## 5.2. COMBINED APPLICATION PLANNING SCHEME VARIATION AND ROL (1 INTO 5 LOTS) 6 ENDEAVOUR ST, PT DOUGLAS

<b>REPORT AUTHOR(S)</b>	Jenny Elphinstone, Senior Planning Officer
<b>GENERAL MANAGER</b>	Michael Kriedemann, Acting General Manager Operations
<b>DEPARTMENT</b>	Development Assessment and Coordination
<b>PROPOSAL</b>	Combined application to reconfigure the land into five lots and for a preliminary approval to vary the effect of the Planning Scheme for a material change of use for a house on four of the new lots.
<b>APPLICANT</b>	The Corporation of the Diocesan Synod of North Queensland C/- Planz Town Planning PO Box 181 Edge Hill QLD
<b>LOCATION OF SITE</b>	6 Endeavour Street Port Douglas
<b>PROPERTY</b>	Lot 2 on RP739097

### RECOMMENDATION

Drawing Title  
**PROPOSED RECTORY SITE PLAN**

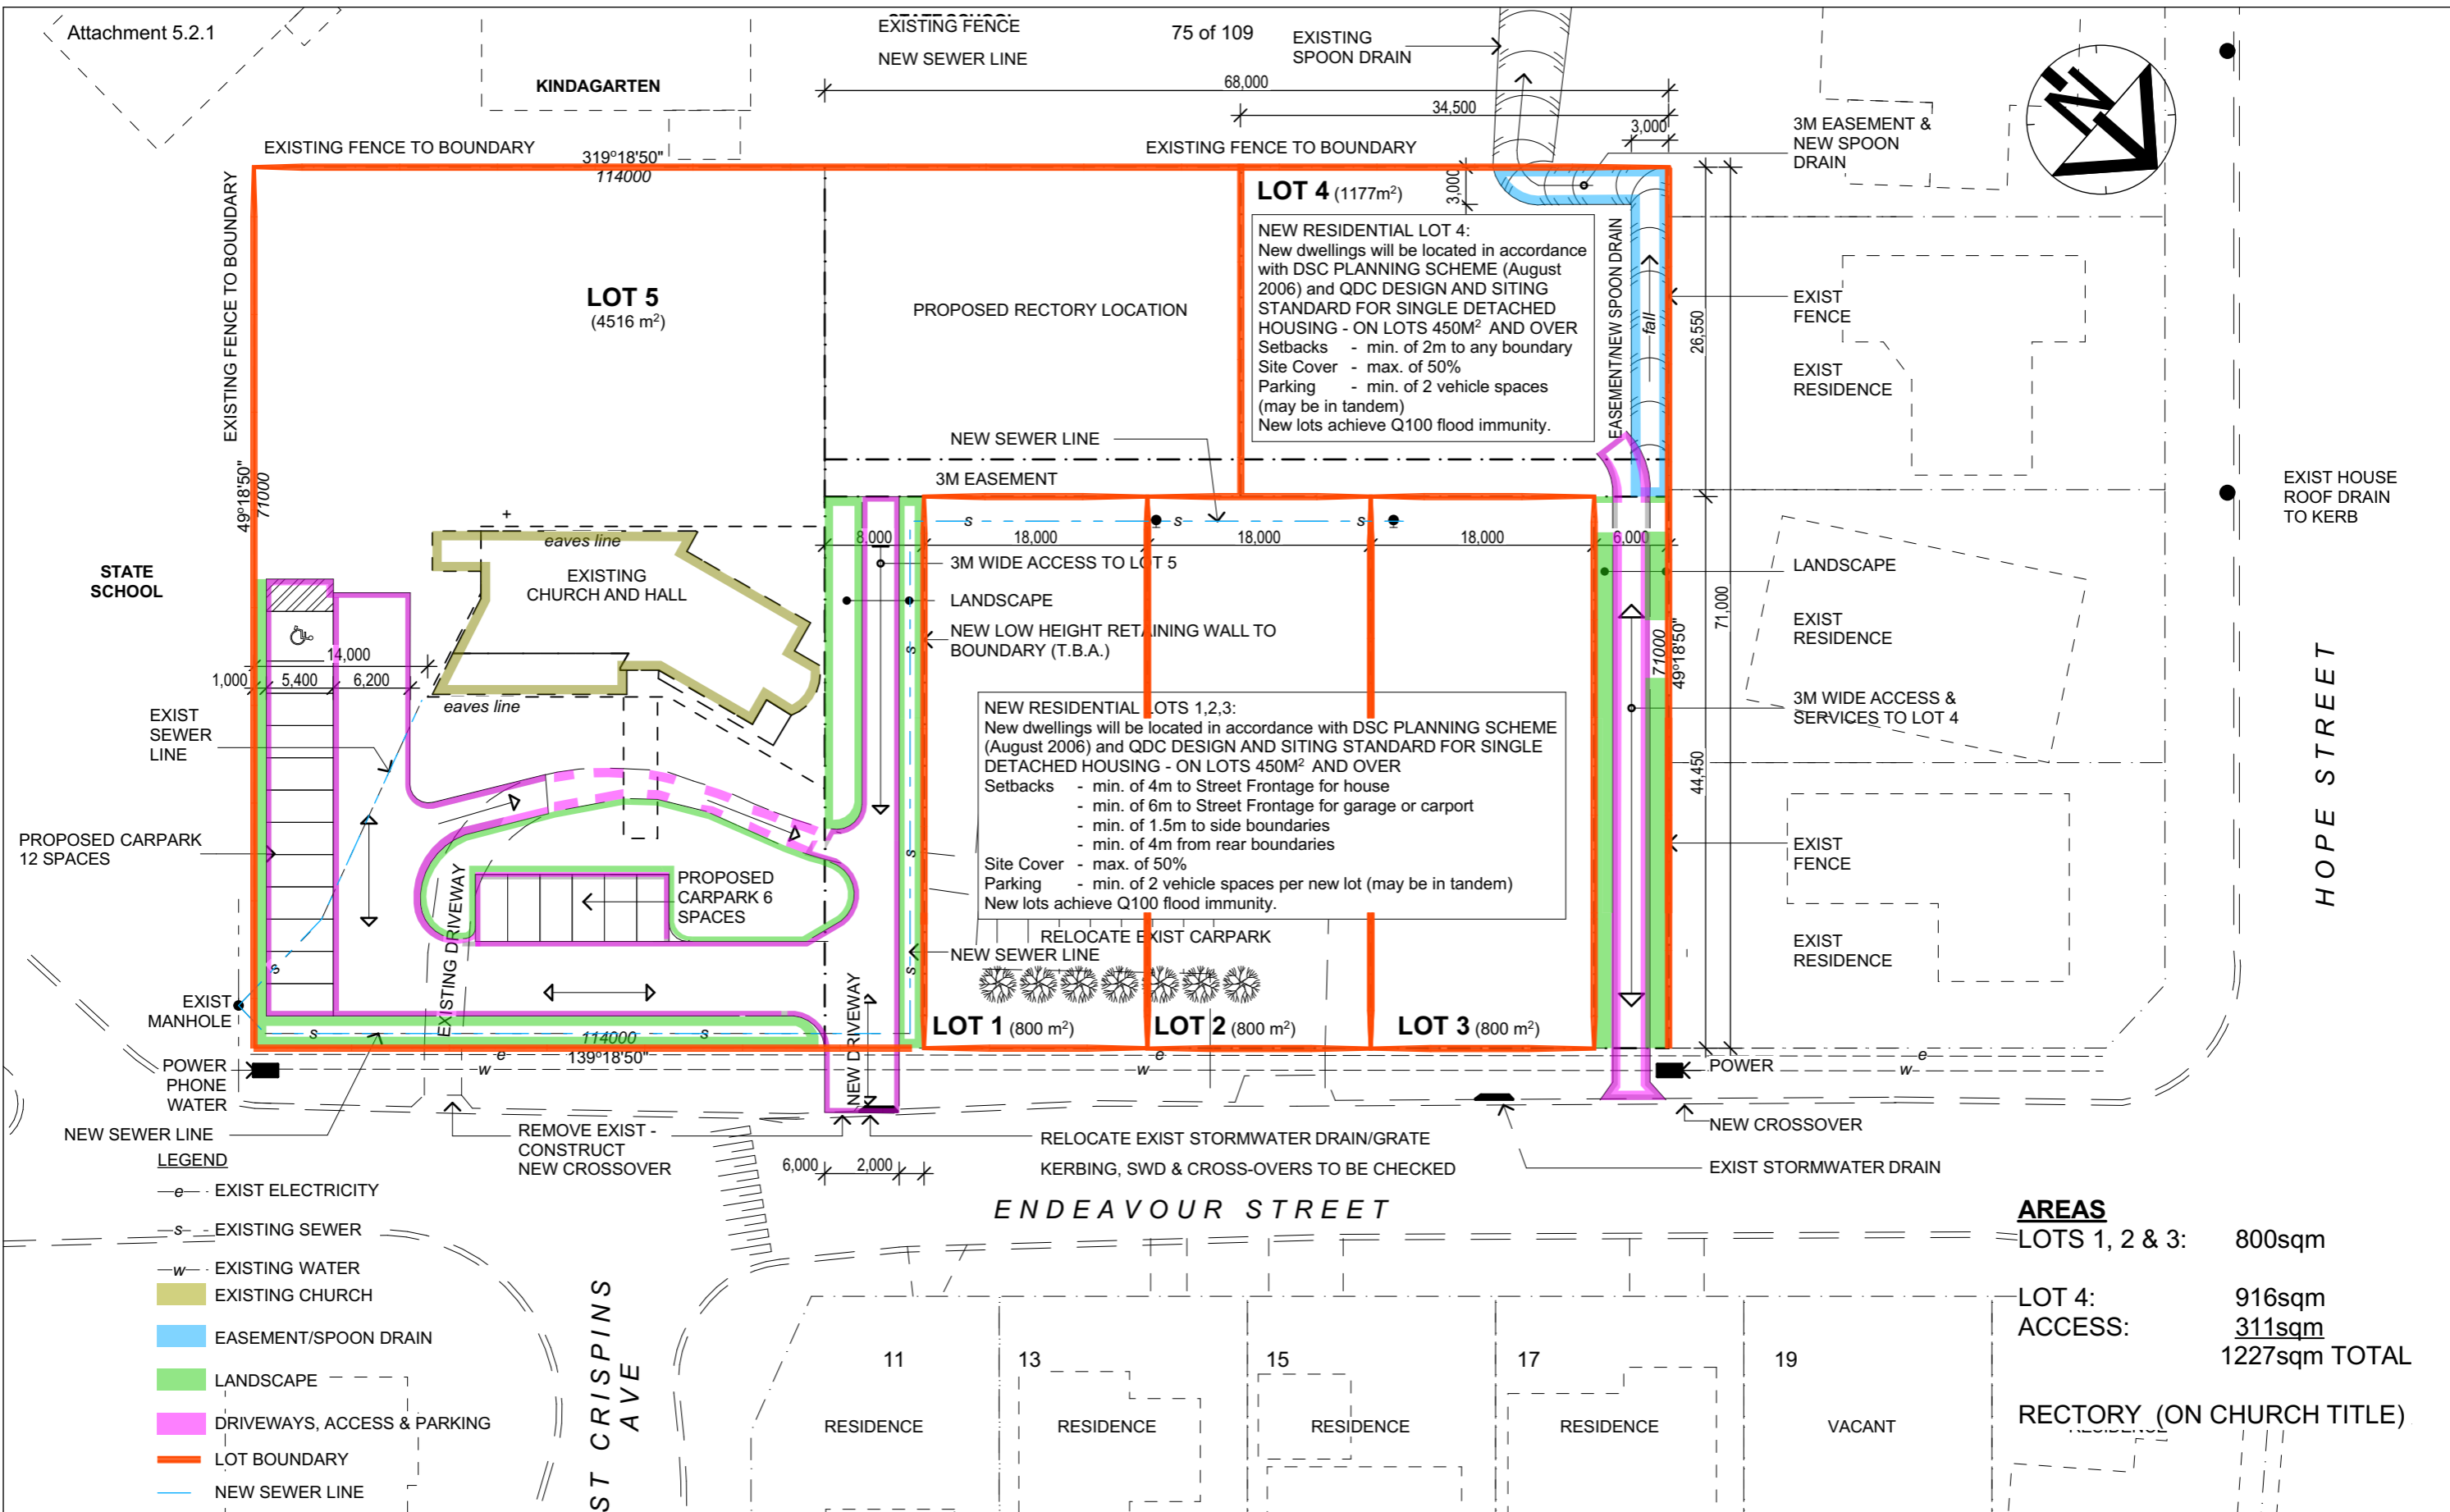
The creation of a separate lot for the Church and rectory incorporates a relocation of the associated car parking to within 6m of the street boundary and within 3 metres of the side boundary. The relocation of the car park is constrained by the position of the built form including the covered passenger drop-off to the Church entrance. The parking to the southern boundary, to the Primary School, is setback 1.0m from the common boundary fence. A condition of the approval requires wheel stops to these car parking spaces to provide safety to this boundary.

The Planning Scheme seeks an acceptable outcome for a minimum 2m wide densely planted buffer to all side boundary setback areas. The setback from the car parking area is discussed above. There is a 2m separation between the driveway to the rectory and the common boundary to the new lot and this area should be landscaped with deep planting.

3. **The lot design is to be generally in accordance with Best Overend & Associates Drawing, Proposed Rectory Site Plan, WD0,3 Revision D dated 27 September 2017 subject to:**
  - a. **Proposed Lots 1, 2, 3 and the balance Church lot (Lot 5) must be regraded to drain directly to Endeavour Street;**
  - b. **Proposed Lot 4 may drain to the west, provided:**
    - i. **An easement is created over proposed Lot 4 to accept stormwater discharge from neighbouring properties that front Hope Street;**
    - ii. **The drainage is to a lawful point of discharge; and**
    - iii. **There is a no actionable nuisance or negligible impact to neighbouring or surrounding land or catchment area for 100% of post development flows on the proposed Lot (consider full development (100%) site coverage) and the existing stormwater discharge from neighbouring Hope Street land in a 1% AEP rainfall event;**

- i. Provide a low screen, deep planted landscaped buffer of approximately 500mm high to the front setback of the Church balance land (proposed Lot 5).

JOB No	K-2950
SHEET	SK3   B
SCALE	1:250 (@A1)

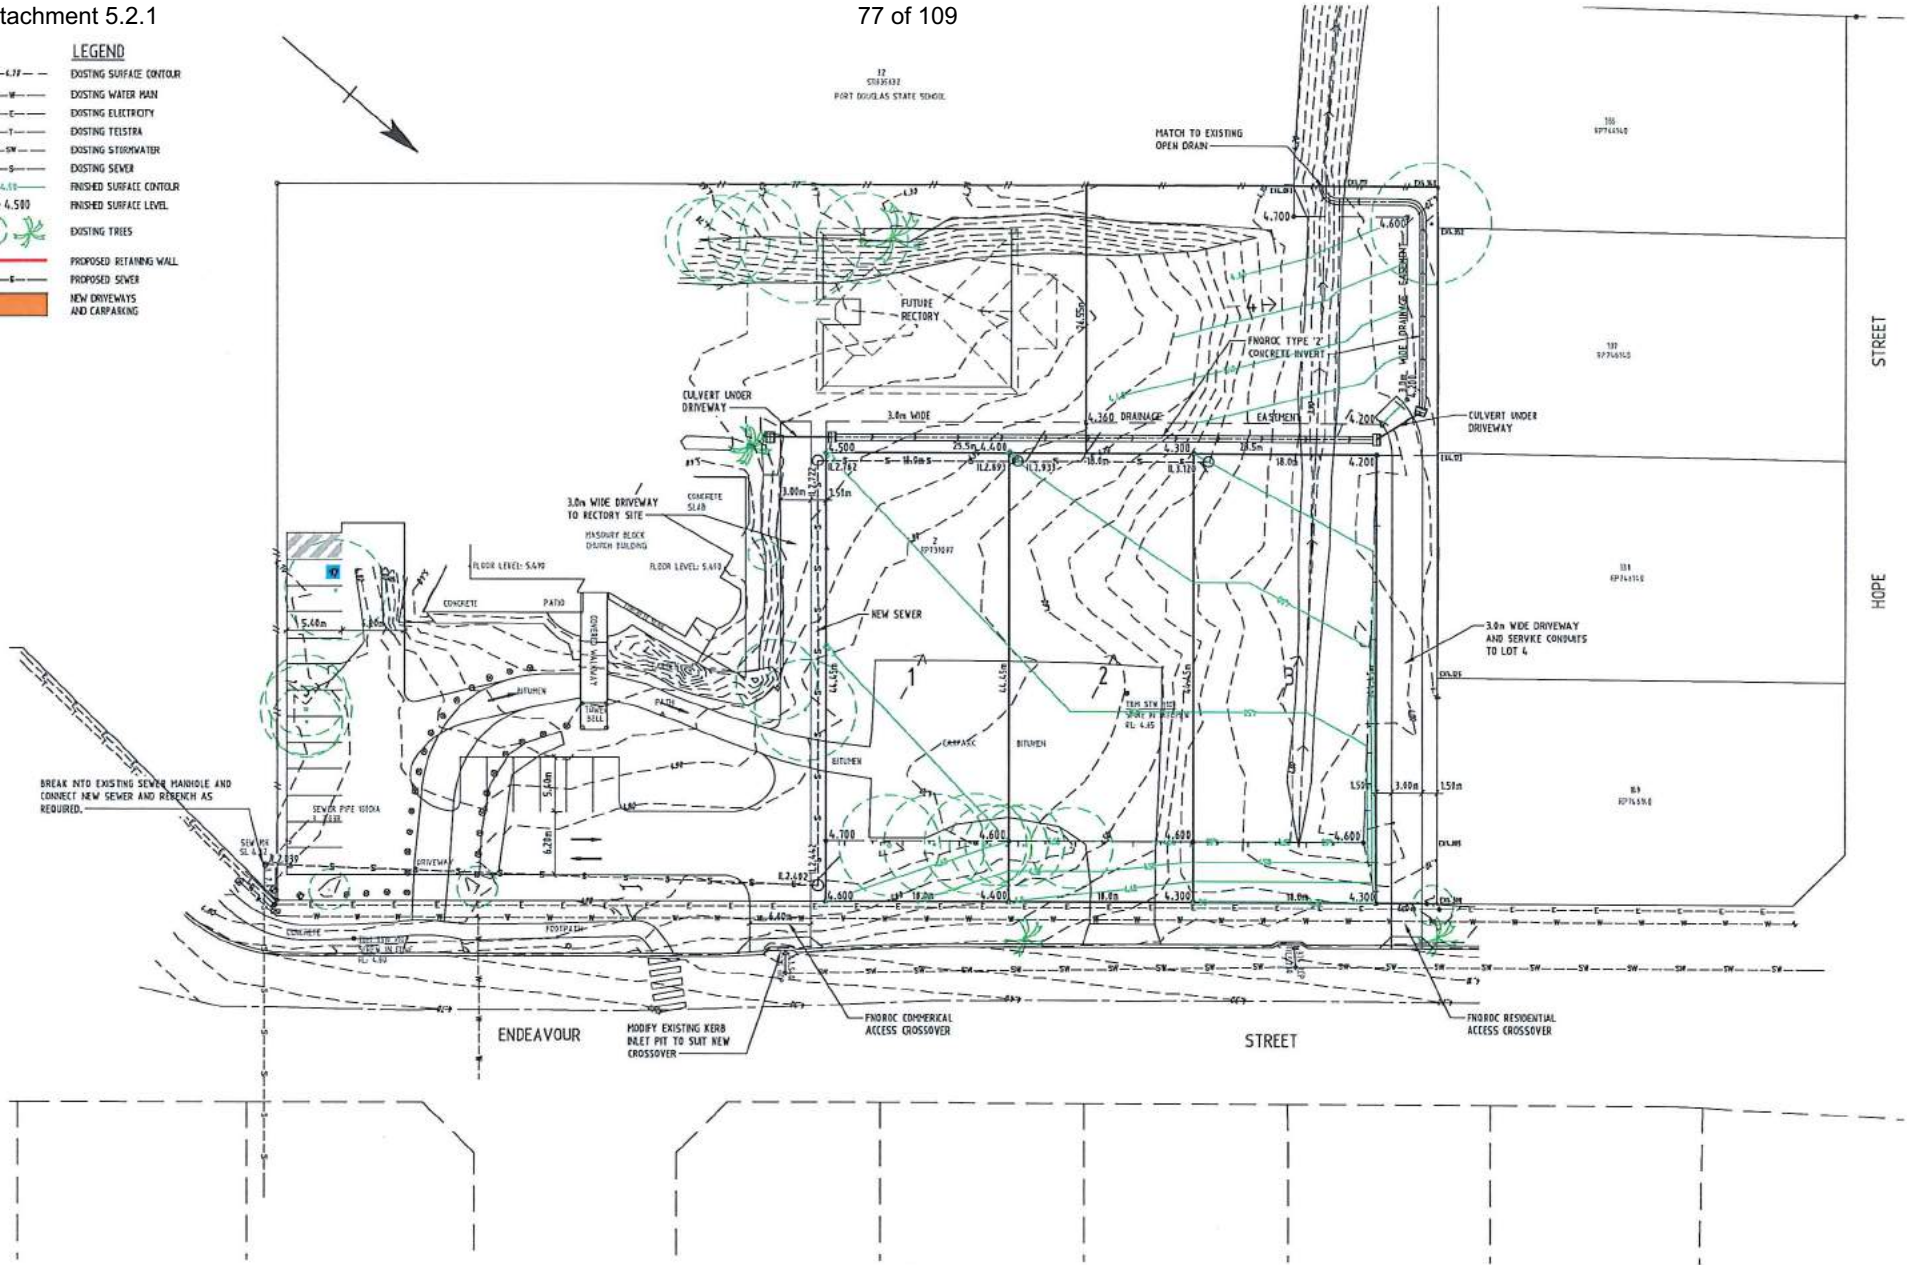
The applicant's plan nominates the new sewer to align to the rear boundaries. This design is not supported and the applicant has indicated the realignment to the front of the lots can be achieved. A condition of the approval requires the realignment.

The applicant's plan proposes stormwater to drain to the rear, to the west, as per the current situation, firstly to the school and then to Council land. The applicant's design requires an open drain and easements over the battle-axe lot. This design is not supported. The placement of drains at the rear of lots, despite being encumbered by an easement, may be difficult and cumbersome to maintain, particularly during major events. The use of the battle-axe lot would be constrained by the easements and drains. A requirement to drain the land, except proposed Lot 4, to Endeavour Street has been raised with the Applicant. The applicant is concerned that directing stormwater may lead to increasing the extent of sag in the current stormwater design occurring in Egret Street. To date no detailed local study has been undertaken by the applicant and the extent of impact is unknown. Given the existing situation, a negligible impact may occur and this is outcome considered acceptable. Should more than a negligible impact occur, the applicant must identify suitable option(s). It is only the applicant's component of an actionable nuisance that Council can call on through the consideration of reasonable and relevant conditions.

Concern was raised with the initial design, with the conflict of the driveway, for the Church and rectory, over the pedestrian crossing on Endeavour Street and the multiple vehicle crossings to the street. The applicant's response to further information addressed this issue by separating the driveway to the Church and rectory away from the pedestrian crossing. It is important that the landscaping adjacent to this front boundary have a low profile to provide high visibility to the adjacent footpath and roadway for safety for school children. These matters are addressed in the conditions of the approval. The relocation of the vehicle access to the Church provides a non interrupted connectivity of footpath between the School and the pedestrian crossing.

- e. Relocate the new sewer extension line to the front of the lots, with a standard off-set alignment as per FNQROC Development Manual. The plan must identify a single sewer connection for each lot at the Endeavour Street frontage. The connection for proposed Lot 4 must be adjacent to the Endeavour Street frontage. Only one sewer connection is to be provided to the balance Church lot (proposed Lot 5);
